# Access Compliance Report

## Public Rights-of-Way

Intersection ID: 48496	Main Street: LOCH_LOMOND_DR	Cross Street: CASTLECOVE_RD	Location: E
ADA ID: 131C97D3E1BD	Ramp Type: PerpDiag	Initial Pass/Fail: Fail	Overall Compliance: No
Codes/Mitigation Info/Possible Solution		Field Measurements/Component Compliance

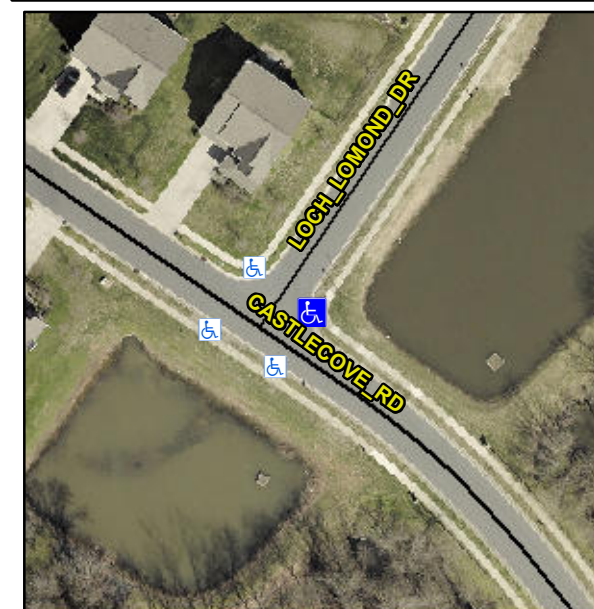
**Remove & Replace Curb Ramp With Two New Directional Ramps or Equivalent.**

**R304.5.1, R304.2.2**

Compliance	Description	Data	Compliance	Description	Data
N/A	Ramp Length (in)	48.0	No	Ramp Slope (%)	10.3
No	Ramp Width (in)	45.5	Yes	Ramp XSlope (%)	0.5
N/A	Flare Type LT	N/A	N/A	Flare Type RT	N/A
N/A	Flare Slope LT (%)	N/A	N/A	Flare Slope RT (%)	N/A
N/A	Flare Traversable LT?	N/A	N/A	Flare Traversable RT?	N/A
N/A	Landing Length (in)	N/A	N/A	DWS Provided?	N/A
N/A	Landing Width (in)	N/A	N/A	DWS Contrast?	N/A
N/A	Landing Slope (%)	N/A	N/A	DWS Length (in)	N/A
N/A	Landing X Slope (%)	N/A	N/A	DWS Full Width?	N/A
N/A	Landing Curb? (Y/N)	N/A	N/A	DWS Offset (in)	N/A
N/A	Shared Landing?	N/A			
N/A	Gutter Ponding?	N/A	N/A	Gutter Slope (%)	N/A
N/A	Gutter Lip Ht (in)	0.5	N/A	Gutter X Slope (%)	N/A
N/A	Painted X Walk1?	No	N/A	Painted X Walk2?	No
	X Walk 1 Direction	To NW		X Walk 2 Direction	To SW
N/A	X Walk 1 Width (in)	N/A	N/A	X Walk 2 Width (in)	N/A
	X Walk 1 Slope (%)	0.8		X Walk 2 Slope (%)	2.4
	X Walk 1 X Slope (%)	0.7		X Walk 2 X Slope (%)	0.6
